SUBJECT: Forwards responses to questions raised re fire protection analysis.Diesel generator room drawings encl.

November 29, 1979
LDR-79-326

QUESTIONS AND ANSWERS CONCERNING
THE
DUANE ARNOLD ENERGY CENTER
FIRE HAZARD ANALYSIS

Diesel Generator Rooms
Proposed Sprinkler System
addition (Item 5)

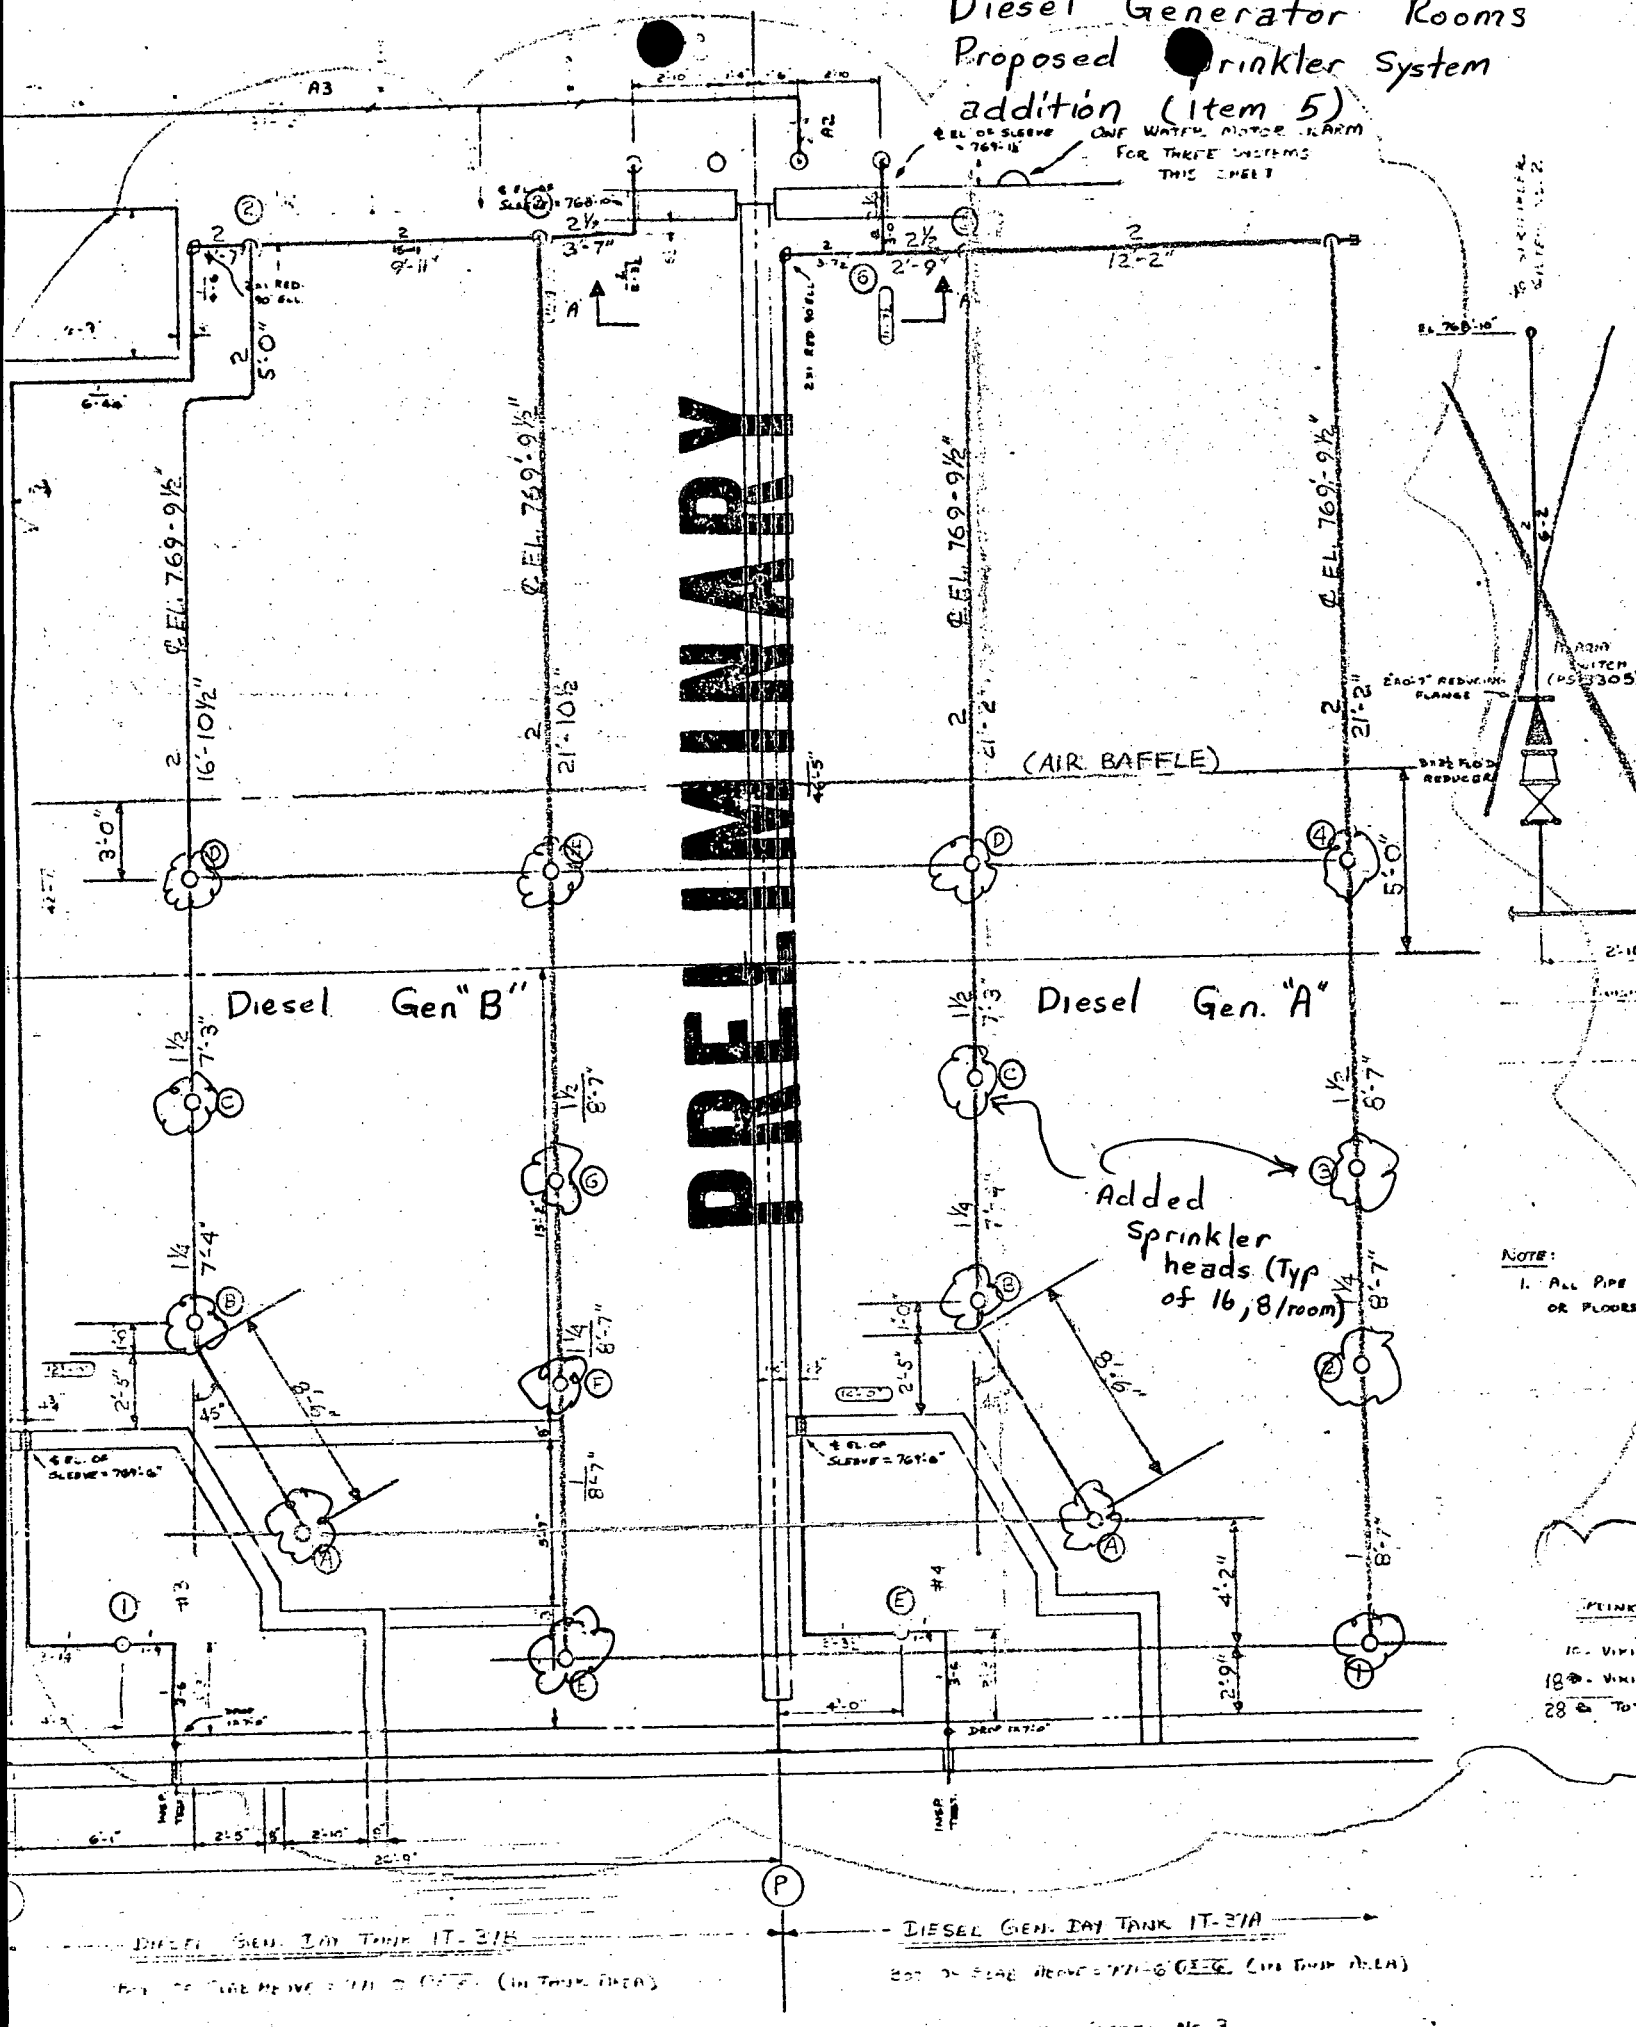
5. Drawings that we provided for the Emergency Diesel Generator Room were only plan views. They would like to see sprinkler layout drawings and would like information on system coverage densities, type of detection, and system trip points.

Attached is a preliminary sketch of the proposed sprinkler layout. This sketch is only a guide used for design calculations. The contractor will be required to finalize the design. A coverage density of 0.30 gpm/ft^2 is required. The system will have a rate of rise release to put water into the sytem prior to fusing of the sprinkler. It is estimated that 8 additional 1/2" upright spray sprinklers will be added to each room but actual numbers will be dependent upon contractors final design.

Diesel Generator Duct Revision (Item 6)

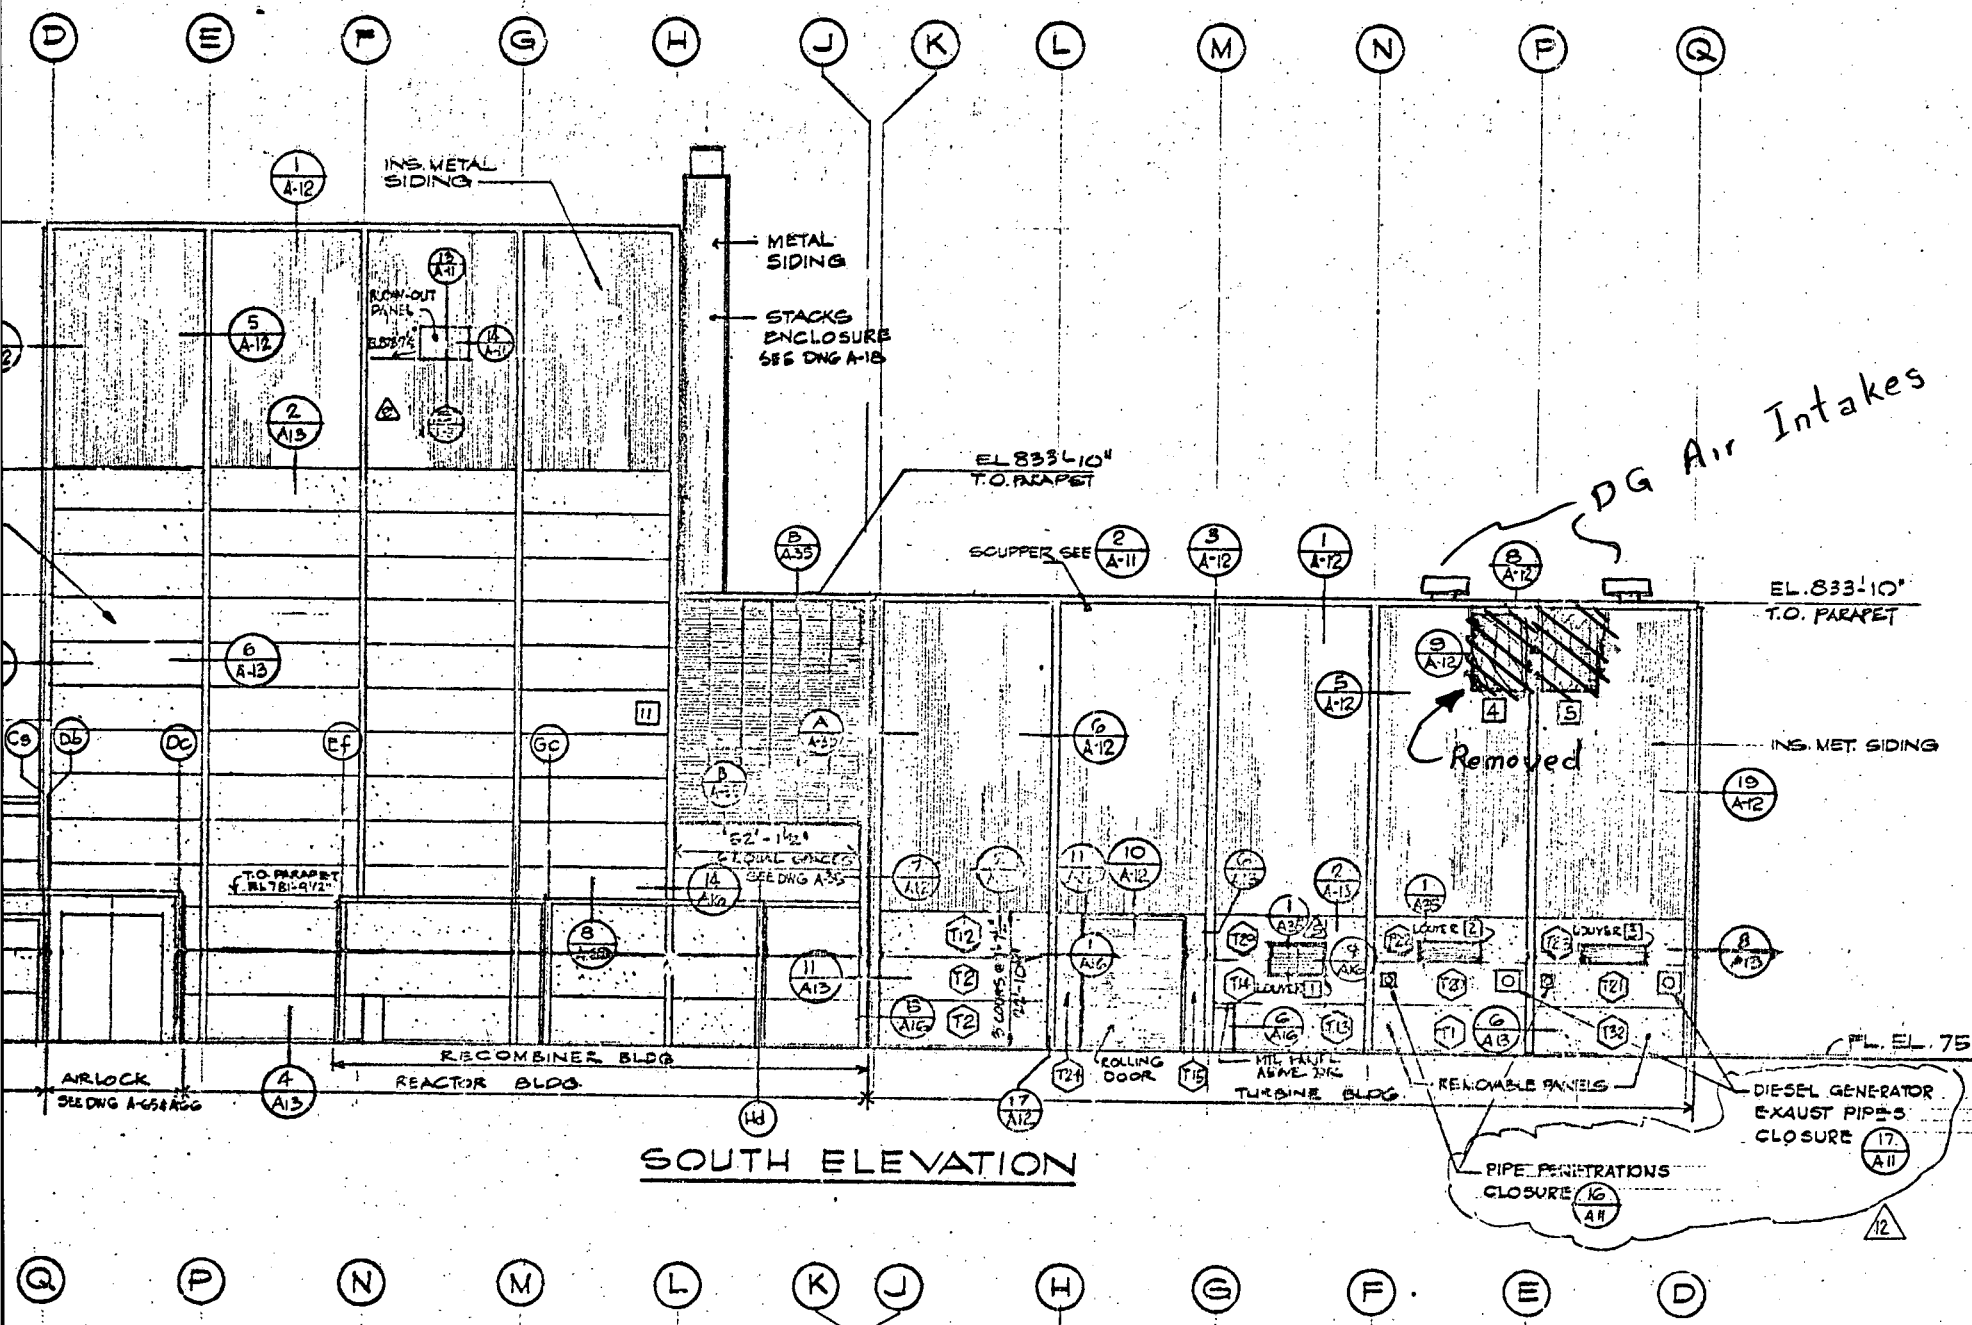
6. A question remains concerning our analysis and design modifications for air intake into the Emergency Diesel Generator rooms.

Please see the attached drawings which show how we intend to take intake suction from above the Turbine Building roof.
